Chapter 4

REVISIONS TO THE DRAFT ENVIRONMENTAL IMPACT REPORT

This chapter describes and presents revisions made to the Draft Environmental Impact Report (DEIR) for the Estrella Substation and Paso Robles Area Reinforcement Project (Proposed Project). The DEIR was revised based on certain specific comments, as identified in Chapter 3, *Individual Responses to Comments*, as well as to update the document and create the Final Environmental Impact Report (FEIR) and to ensure consistency with changes made in the Recirculated DEIR. All substantive, new revisions to the DEIR are shown in underline/~~strikeout~~ in this chapter and in Volumes 1 (Main Body) and 2 (Appendices) of this FEIR. As described in Chapter 1, *Introduction*, revisions to the DEIR¹ that were previously made as part of the recirculation have been accepted in this FEIR and are not included in this chapter.

Figure 4.7-2
Fault Zones

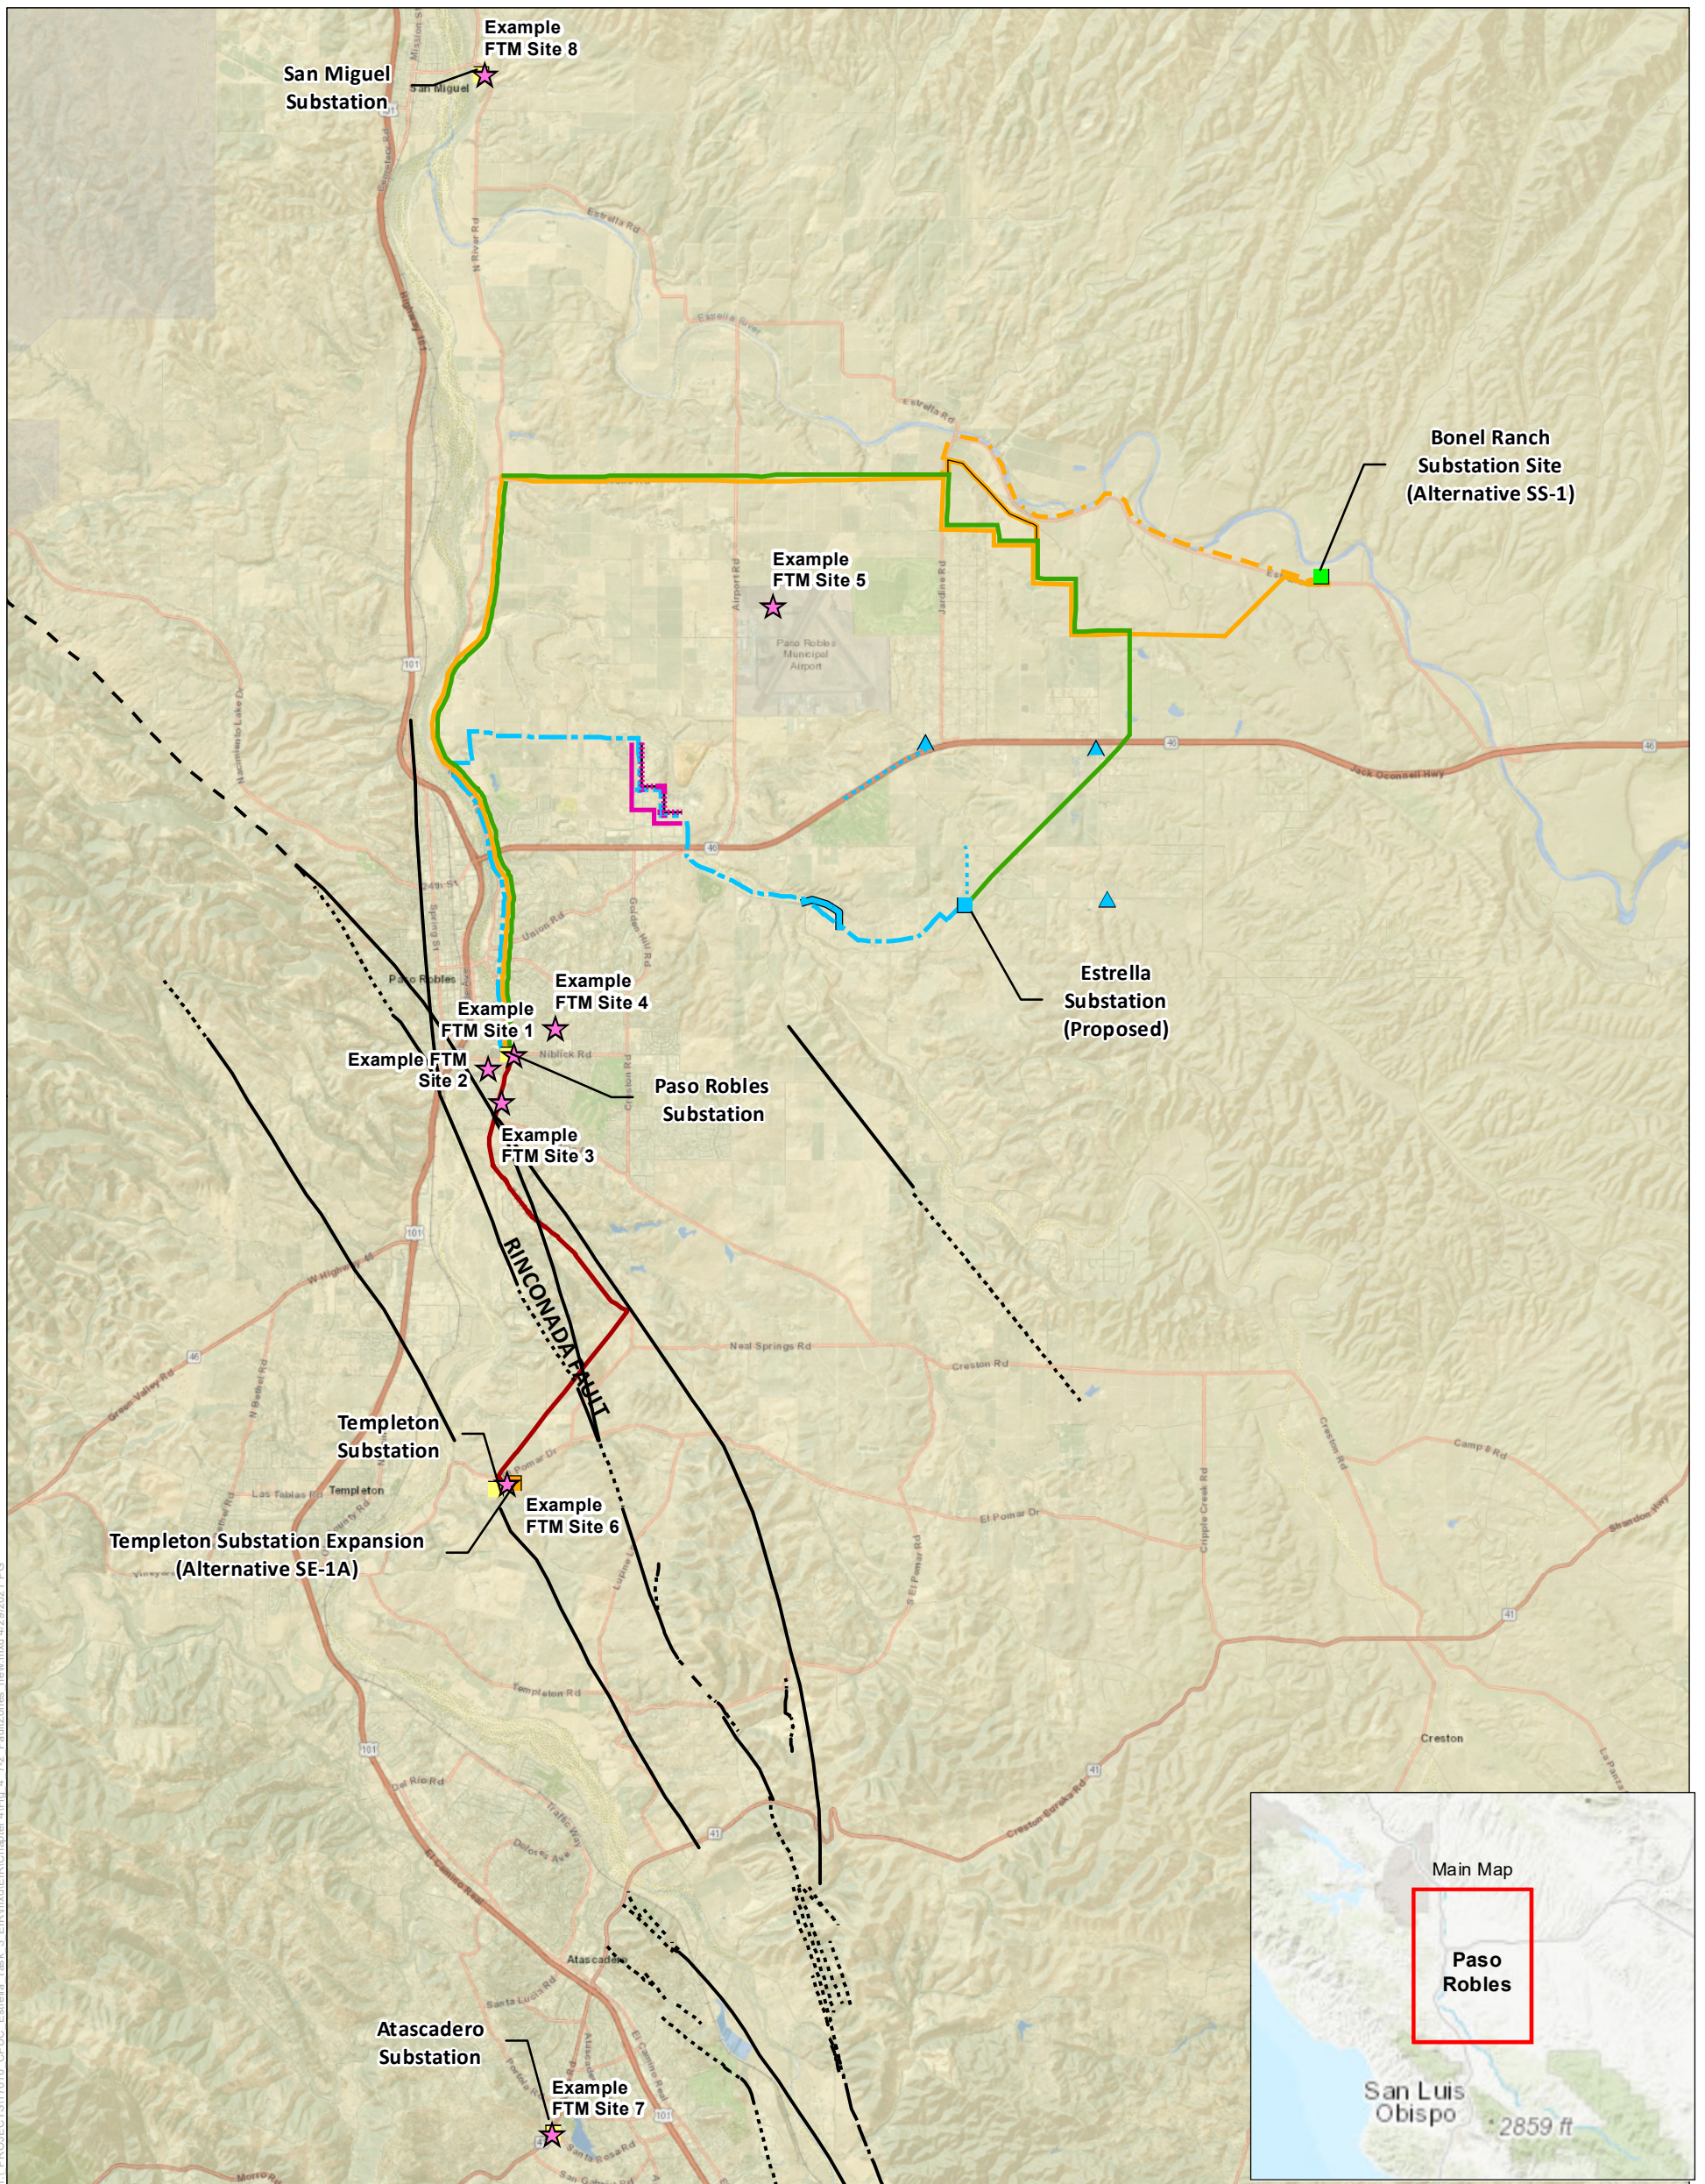
In response to Comment L-16, Figure 4.7-2 on page 4.7-15 has been revised to reflect additional branches of the Rinconada Fault. The existing figure has been replaced with a revised version shown on the following pages.
